Regulation No. 110 (CNG and LNG vehicles)

Proposal for Supplement 1 to the 02 series of amendments to Regulation No. 110 (CNG and LNG vehicles)

Submitted by the expert from France*

Figure 1 **Dimensions of the receptacle**

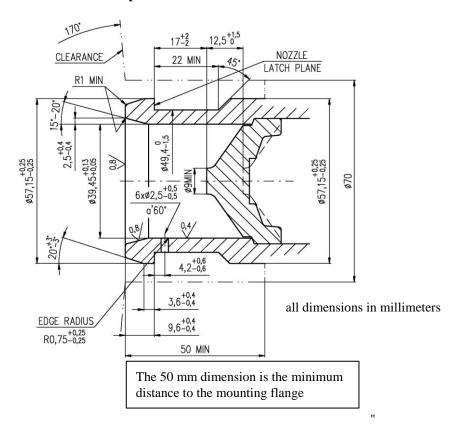
Insert new paragraphs 4. and 4.1., to read:

- "4. LNG filling receptacle dimensions
- 4.1. Figure 1 shows the dimensions of the LNG filling receptacle.
